Re: Florida Power & Light Company  
Proposed Turkey Point Units 6 and 7  
Docket Nos. 52-040 and 52-041  
Voluntary Revised Response to NRC Request for Additional Information Letter No. 043 (eRAI 5875) SRP Section - 02.05.03 Surface Faulting

**NRC RAI Letter No. PTN-RAI-LTR-043**

**SRP Section: 02.05.03 – Surface Faulting**

**Figure 2.5.3-205 Potential Quaternary Tectonic Structures in the Site Region**

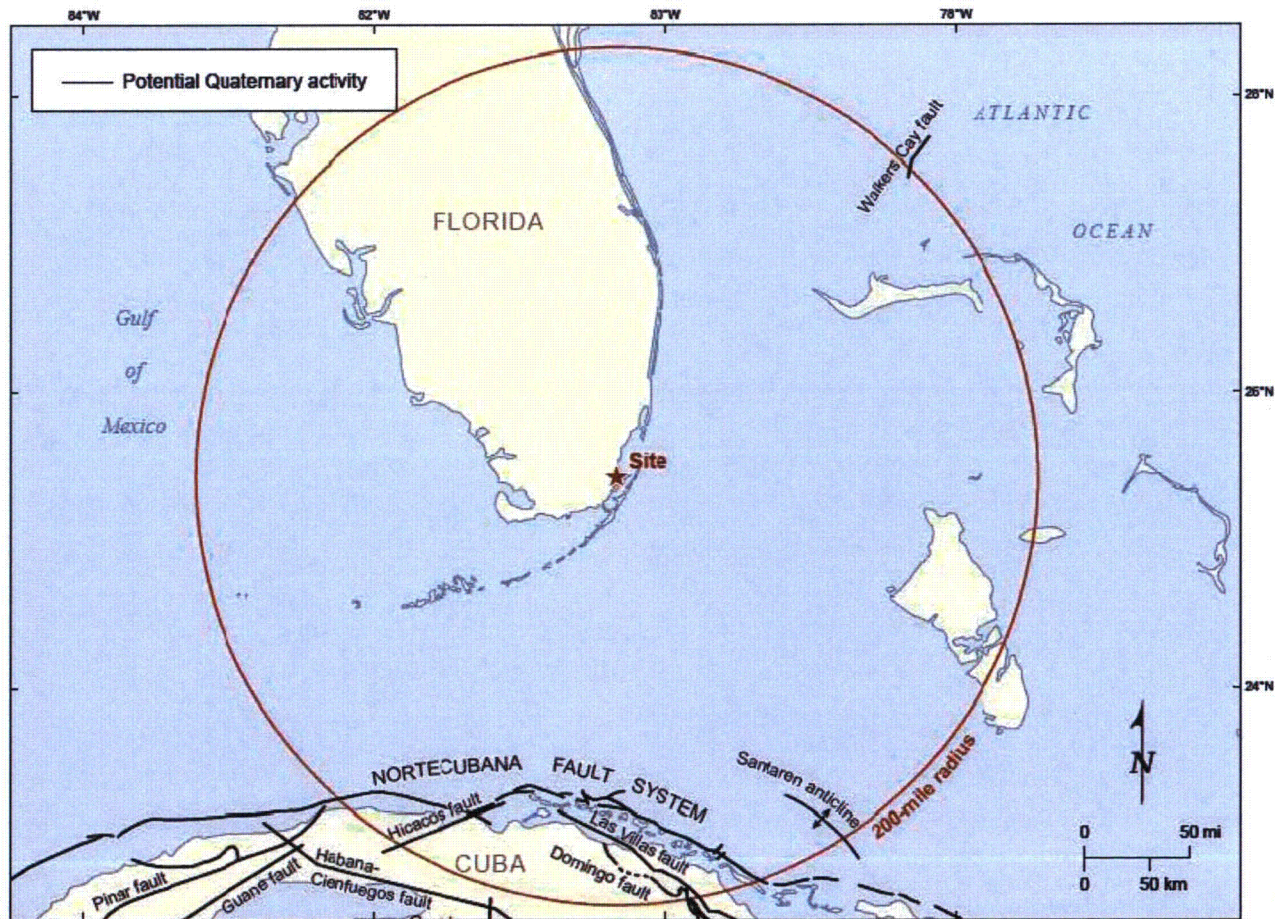
- a) Describe the presence of the Quaternary-active Walkers Cay fault, the Santaren Anticline, and the Straits of Florida normal faults within the site region but outside the Cuba Area Source Zone.
- b) Provide a figure, centered on the site region, which reflects all potential Quaternary active features in the site region.
- c) FSAR Section 2.5.3.7, states that the Cuba Area Source is 160 miles from the site. However FSAR Section 2.5.2.4.4.3.2.1, Cuba Areal Source Zone, states that the source zone is 140 miles from the site (p 2.5.2-60, rev 2). Please clarify the inconsistency.

New FSAR Figure 2.5.3-205 will depict tectonic structures within the site region with potential Quaternary deformation, including the Walkers Cay fault, the Santaren anticline, and faults on Cuba within the site region. So as not to minimize hazard, the Walkers Cay fault has been assigned a Quaternary age, and some faults associated with Cuba may also be active in the Quaternary, although timing of specific structures is not established in published research. Although FPL questions Masferro et al.'s (2002) (FSAR 2.5.1 Reference 479) assertion that the stratigraphic relationships indicate intermittent fold growth into the early Quaternary, the Santaren anticline will be shown as a potential Quaternary structure on FSAR Figure 2.5.3-205. Deformation on the Straits of Florida normal faults occurred in the late Tertiary, and thus, these faults are not included on FSAR Figure 2.5.3-205.

vicinity. Within the site region, seismicity and potential Quaternary deformation are restricted to the **faults within the** Cuba areal source zone, approximately ~~160~~ **140** miles south of the site, **and possible deformation associated with the Walkers Cay fault and Santaren anticline (Figure 2.5.3-205).** No sand blows or paleoliquefaction features have been identified in the published literature for the site region. **Karstic dissolution of limestone is a source of non-tectonic Quaternary deformation found in Florida and the Bahamas within the site region (Subsection 2.5.3.8.2.1 and 2.5.4.4.5).**

FSAR Figure 2.5.3-205 "Potential Quaternary Tectonic Structures in the Site Region" will be added to Subsection 2.5.3 in a future COLA revision as indicated below:

**Figure 1 Illustration from USACE Lineament Study and Barnett (1975) Strike-slip Fault**

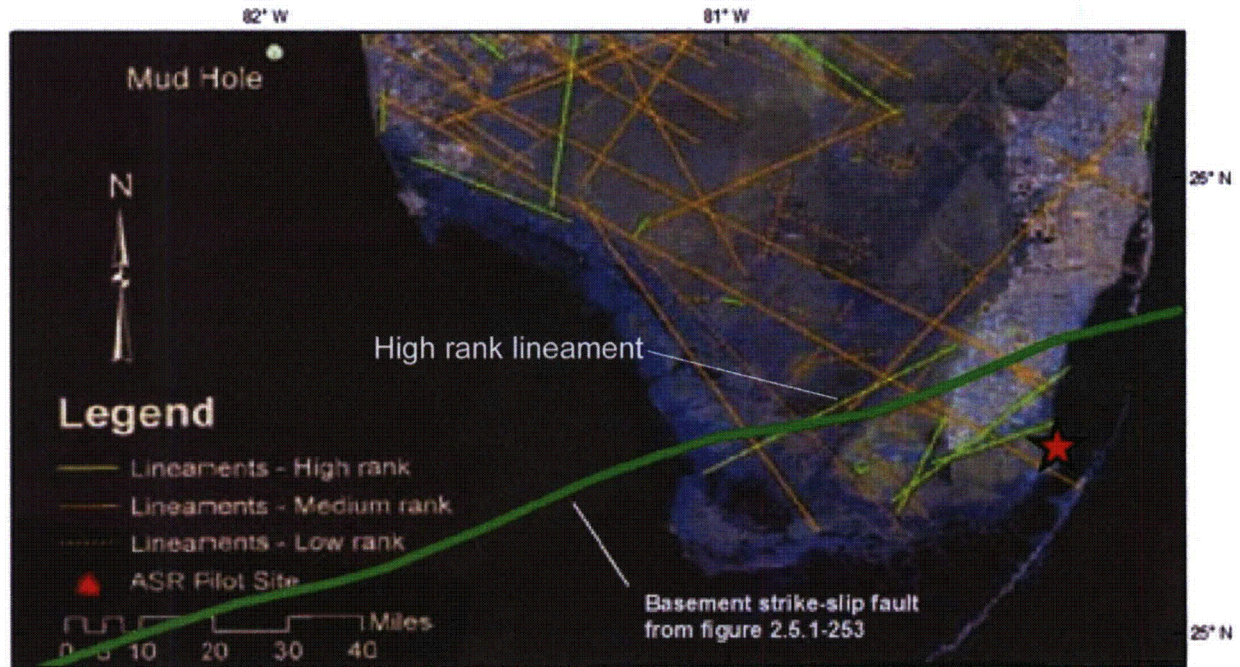
In order for the staff to completely understand the geologic setting of the site and in support of 10 CFR 100.23 please discuss the high-rank lineament shown on Figure 2.5.3-204, and clarify it's relationship with the strike-slip fault north of TPNPP shown on Figure 2.5.1-253. Include a discussion regarding how these figures are in agreement with the FSAR Section 2.5.3.2 statement that no faults have been mapped in the site vicinity. Finally, please clarify this apparent disagreement between the text and figures in the appropriate FSAR section(s).

There is no clear relationship between the postulated buried strike-slip basement fault depicted in FSAR Figure 2.5.1-253 and the high-rank lineament on FSAR Figure 2.5.3-204. As shown in Figure 1, the two features are both northeast-striking, but have different geometries, extents, and locations. The high-rank lineament is more north-striking,

completely straight and mapped onshore, terminating at the Atlantic coastal ridge, while the postulated basement fault strikes more easterly, has a variable strike, and extends tens of kilometers offshore both to the east and west. Where the high-rank lineament is most well defined (at its southwest end, near the mouth of the Shark river), the basement fault is located more than 5 km to the north (Figure 1). No geologic evidence of faulting is reported to support a tectonic origin for the lineaments identified in the USACE study, and no evidence links the postulated basement faults at depth to any lineament at the surface (FSAR 2.5.3 Reference 232). The original study by Barnett (1975) (FSAR 2.5.1 Reference 458) did not interpret geomorphic expression of any of the postulated basement faults depicted in FSAR Figure 2.5.1-253. FPL interprets the similarity in general location (southern Florida) and strike (northeast) of the high-rank lineament and postulated basement fault to be coincidental. Because the high-rank lineament in FSAR Figure 2.5.3-204 is not associated with faulting, this figure provides no conflict with FSAR statements regarding faulting within the site vicinity.

Figure 1 Map of McGregor Isles Area

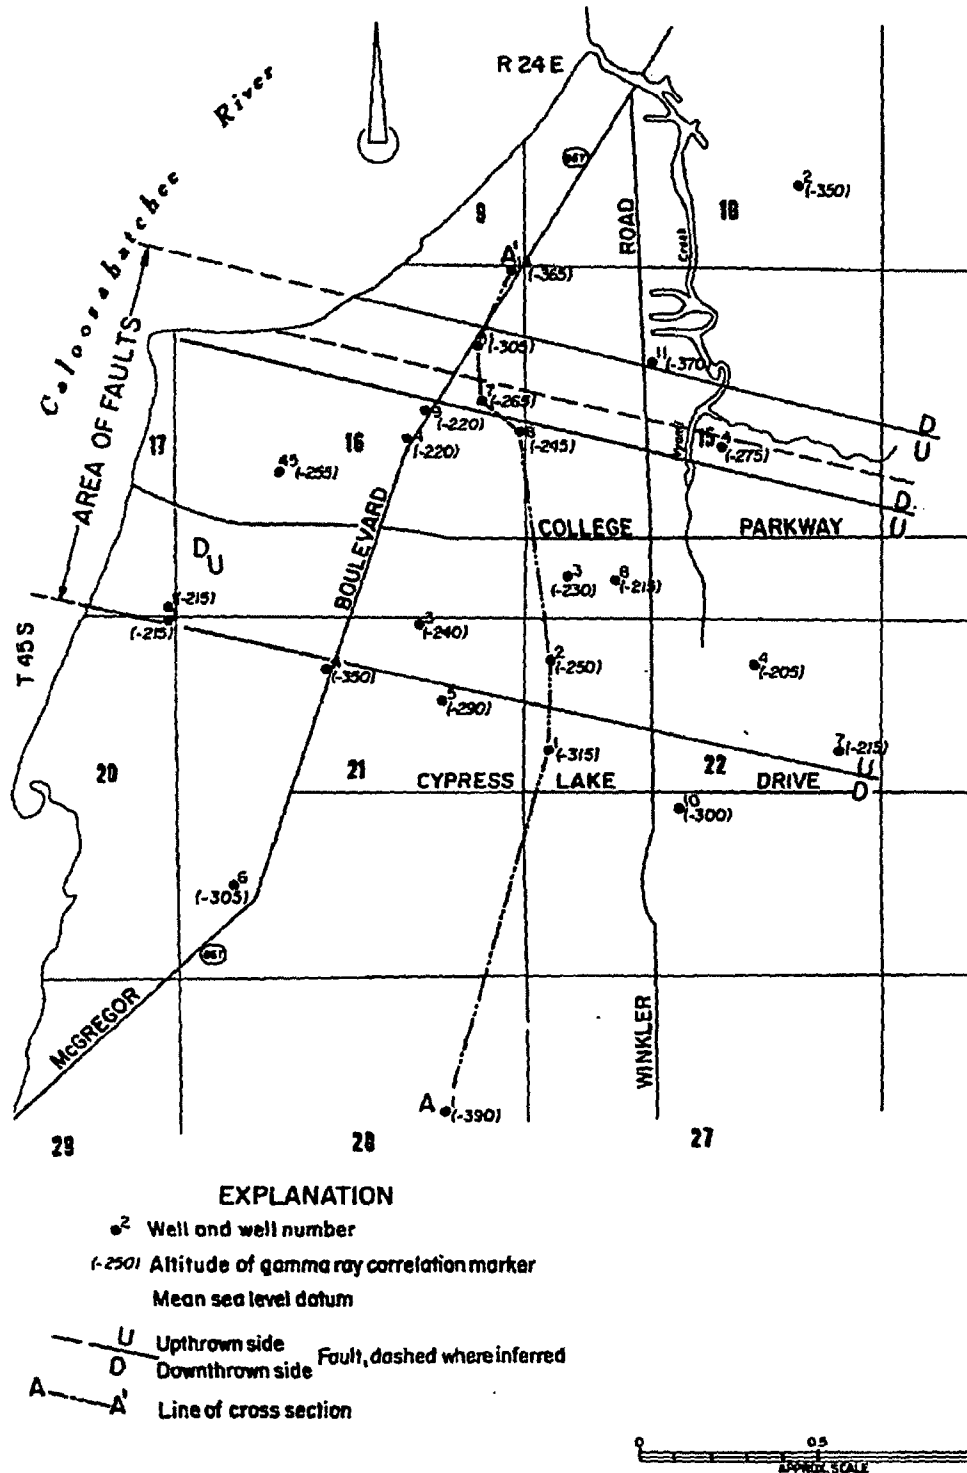
In order for the staff to understand evidence for or against tectonic deformation in Florida Platform specific geology and in support of 10 CFR 100.23, please clarify the apparent inconsistent conclusions that Sproul et al (Reference 230) drew regarding these possible faults. Describe the geomorphic features that Sproul et al referred to and provide more details of your field reconnaissance examination of this area completed for this application.

Sproul et al. (1972) (FSAR 2.5.3 Reference 230) suggest that the “configuration of the Caloosahatchee River shoreline in the vicinity of the northeast corner of section 17 (in Figure 1), and the alignment of a tributary to Whiskey Creek near the center of section 15 are suggestive of fault controlled features” (p. 12 of FSAR 2.5.3 Reference 230) (see Figure 1). The shoreline throughout the northwest corner of section 16 and the southwest corner of section 17 is not aligned with the faults, but a bend in the shoreline does occur near the northern group of 3 faults (see Figure 1). However, the fault located at the apex of the bend is dashed and listed as “inferred”. If the shoreline bend had resulted from Quaternary faulting, the geometry of the bend would indicate apparent dextral slip, not dip-slip as interpreted based on stratigraphic displacement of the marker bed. Surficial strata in this area are mapped as unfaulted Tertiary-Quaternary shell units (Reference 1).

Although the short tributary to Whiskey Creek is subparallel to the proposed faults, the orientation of the main creek drainage in section 15 is at high angles to the trace of the mapped faults, with no apparent offset or deflection along the proposed structures (See Figure 1). A comprehensive geologic mapping effort in Lee County and the Caloosahatchee Basin utilizing well cuttings, cores, quarry pits and the limited natural outcrops does not indicate any surficial faulting in the area (e.g., Reference 1).
